JRPP Reference: 2013SYE105

Address of Site: 2-22 Birdwood Ave & 1-15 Finlayson Street, Lane Cove

Application Reference: DA 194/2013

Description of Proposal: Stage 1 Concept Plan for the redevelopment of the site for the purpose of 4 residential flat buildings, basement parking and on-site landscaping

EXTENT OF SHADOWS CAST BY
PREVIOUSLY SUBMITTED PROPOSED BUILDING FORMS
(THE DIFFERENCE BETWEEN THE RED AND GREEN IS THE IMPROVEMENT)

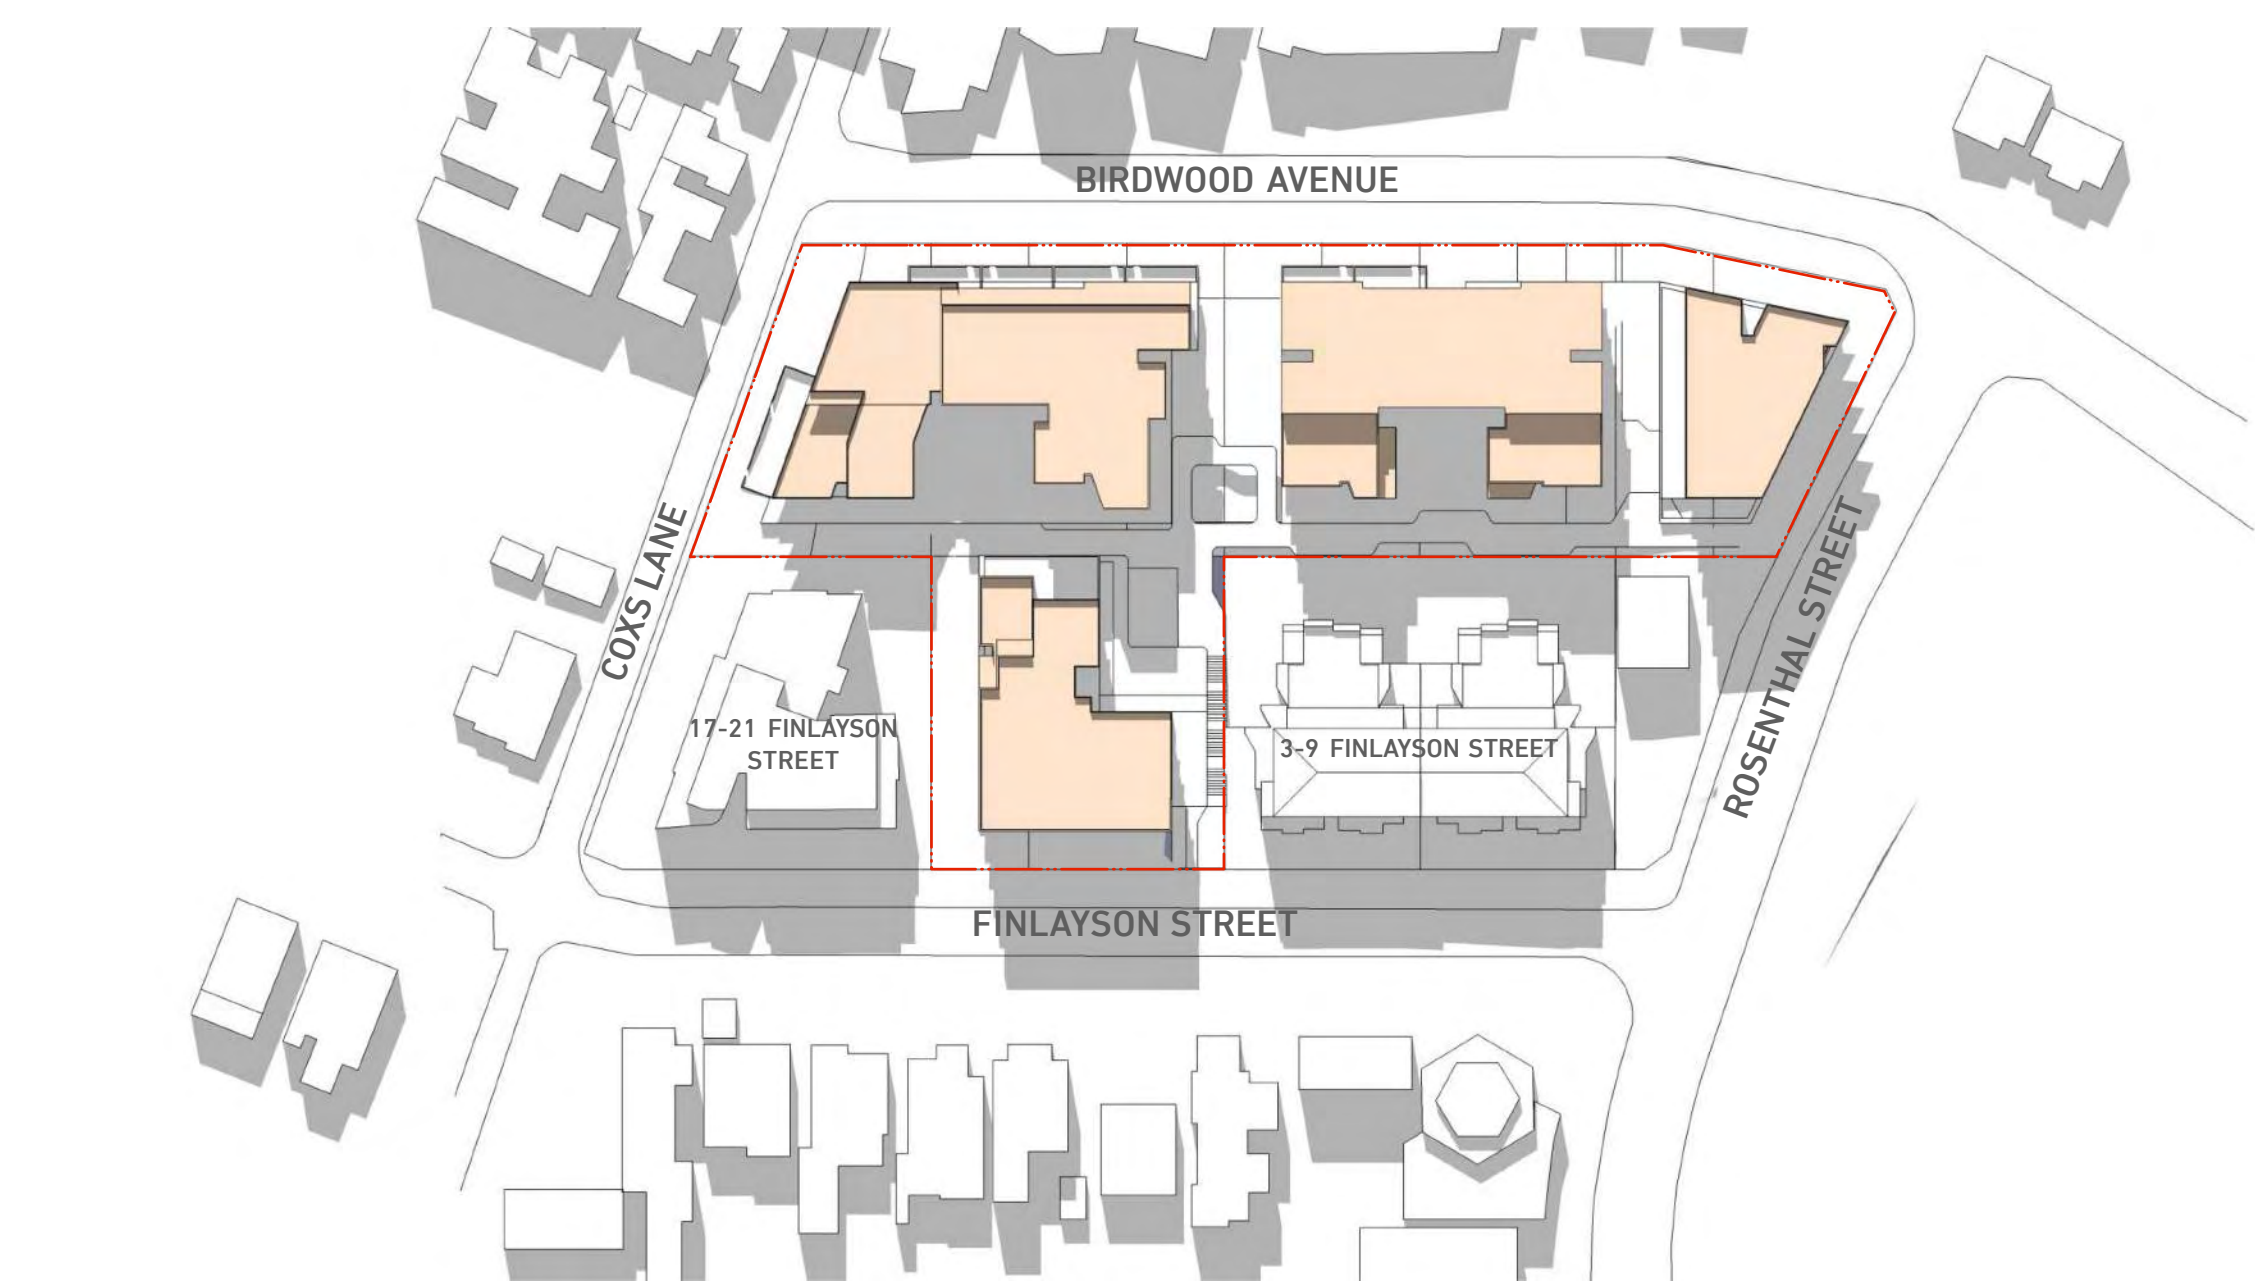
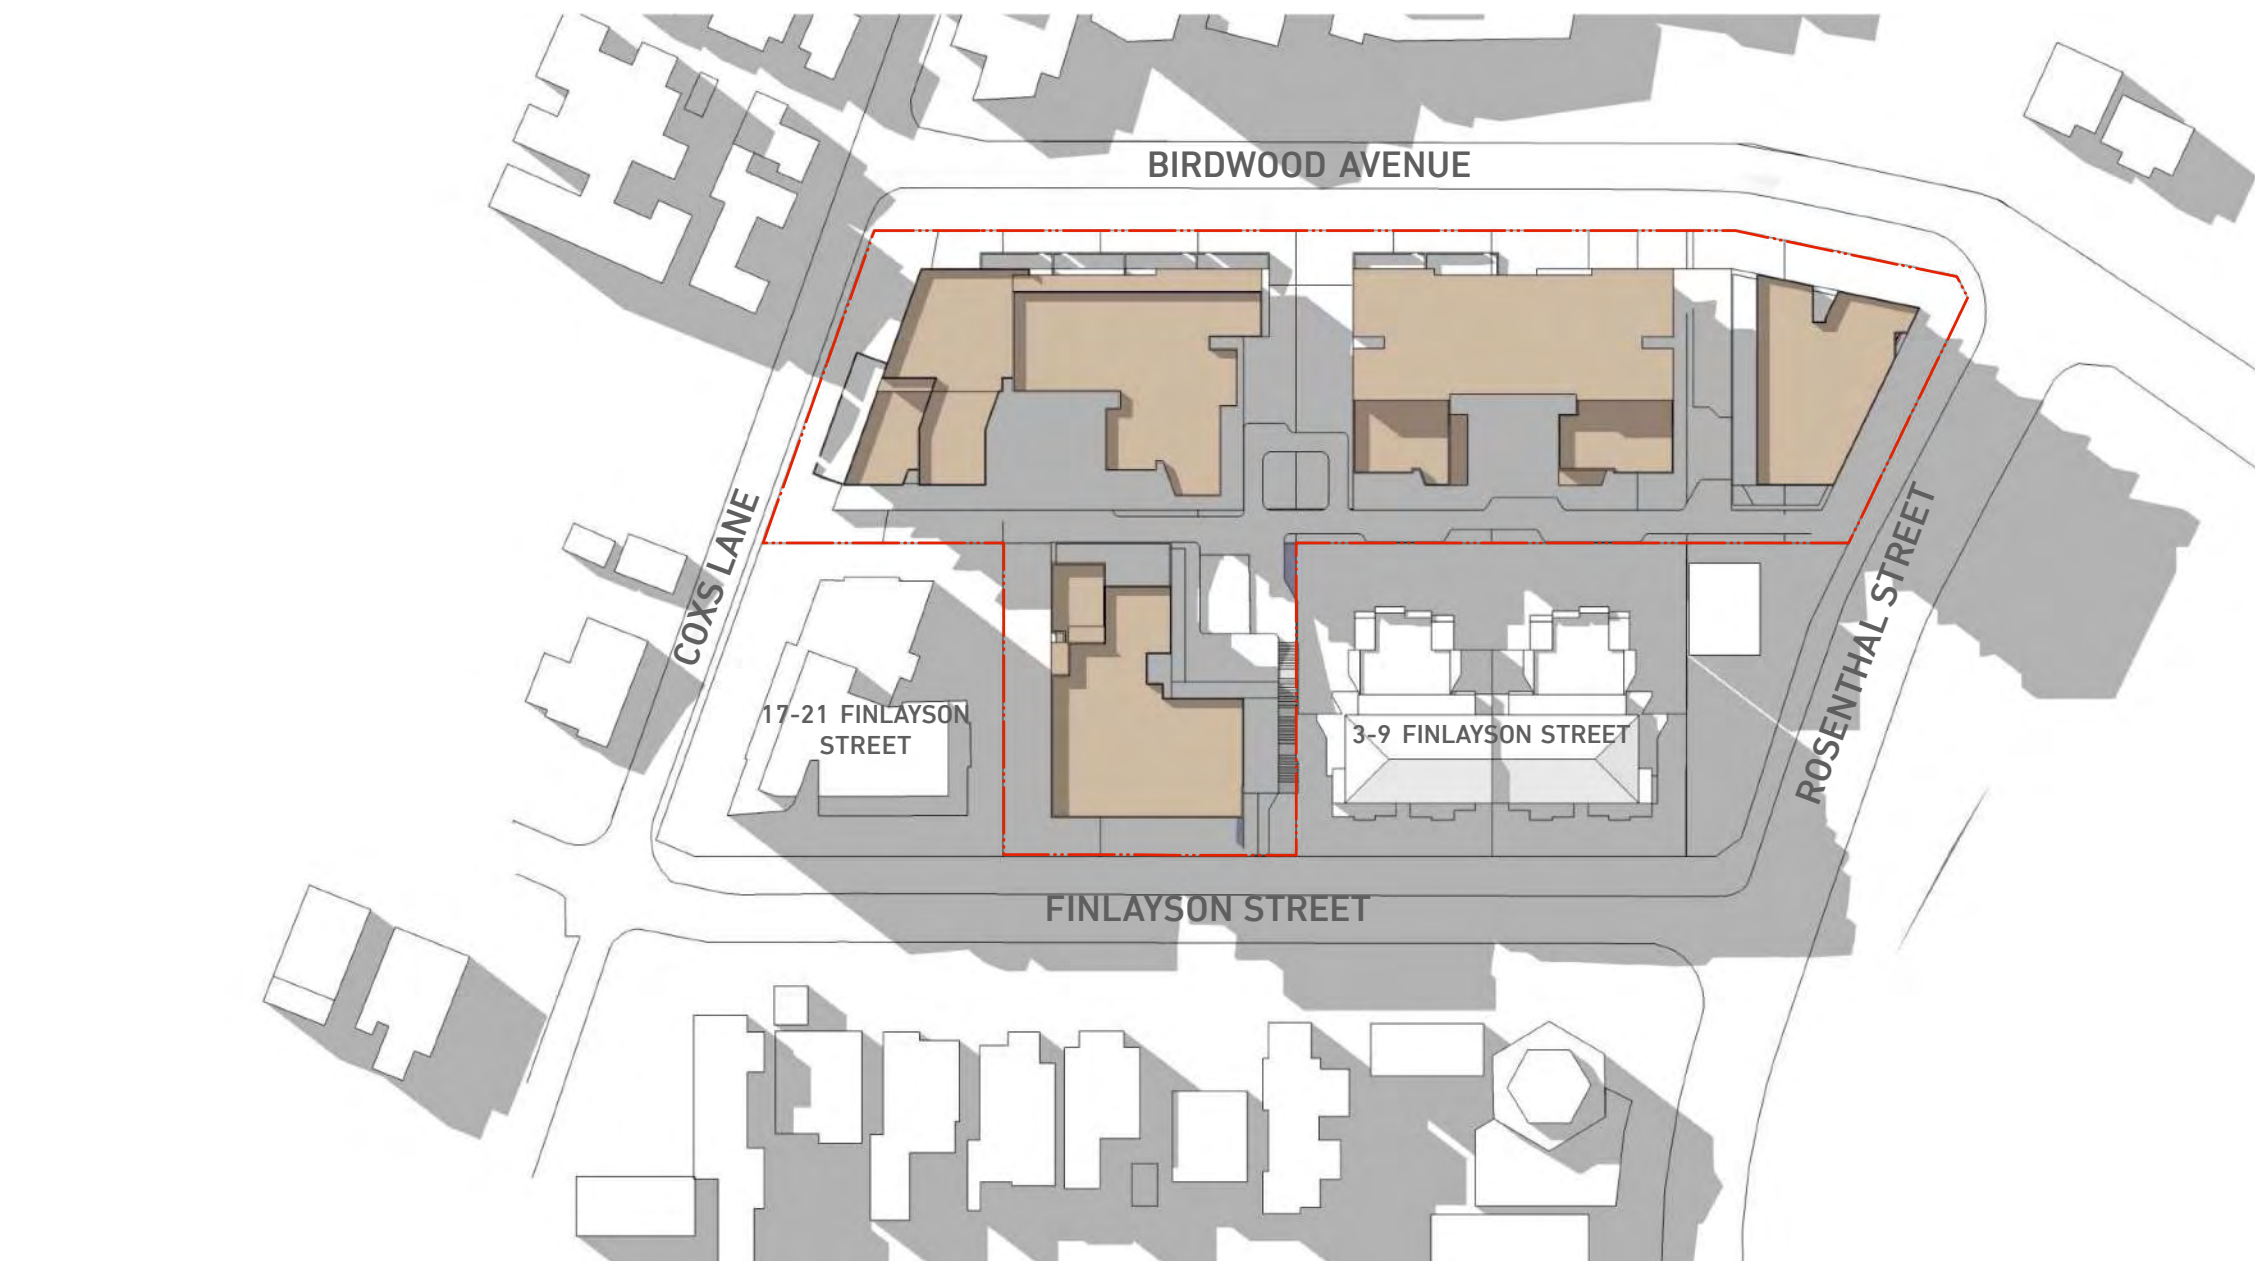
Notwithstanding the above, the proposed amended plans (which will be discussed in the following section of this letter) **improve the level of solar access to the lower level north-facing units of 3-9 Finlayson Street** to a result that is consistent with the RFDC and on balance, better than an outcome from a compliant height scheme.

- 3) Amended mid-winter shadow diagrams for the proposed development to reflect the proposed amendments referred to in 2) above. These diagrams show that proposed Building envelope D does not cast any additional shadow in mid-winter on the eastern-most elevation of the adjacent approved

Figure 2 - Proposed Southern Elevation - View of Building D Envelope from Finlayson Street
Source: Turner

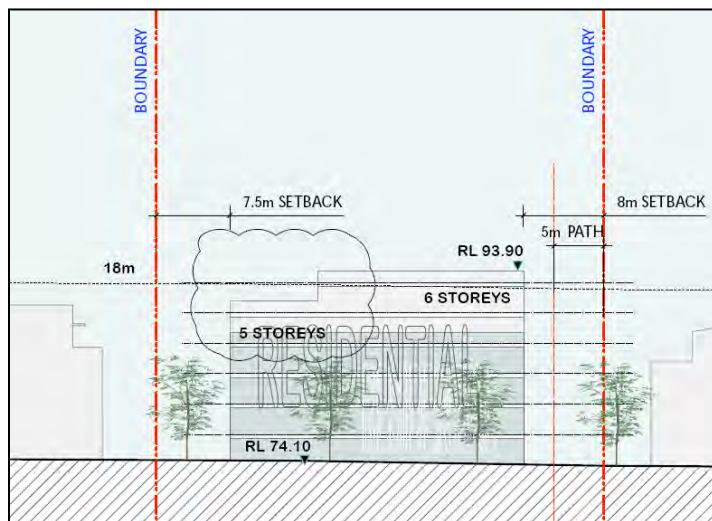
The reduction in the overall scale of proposed Building D also results in a reduced visual impact when viewed from the approved development at 17-21 Finlayson Street and when viewed from the Finlayson Street public domain. This will be further improved in the detailed design of the proposed building envelope, which will be the subject of future stage applications. The elevation below shows where the building envelope for proposed Building D has been amended:

- 2) Amended architectural plans which propose a reduction in the western part of the proposed building envelope for Building D. This results in a reduction in building height in this location, deletion of four (4) units, a reduction in gross floor area of 400m² and a reduction in the proposed floor space ratio for the site from 1.95:1 to 1.92:1. The premise behind these amended plans relates to the additional analysis undertaken in 1) above and to respond to concerns that were raised in the submission made by 17-21 Finlayson Street. Further discussion is provided in this letter in this regard.
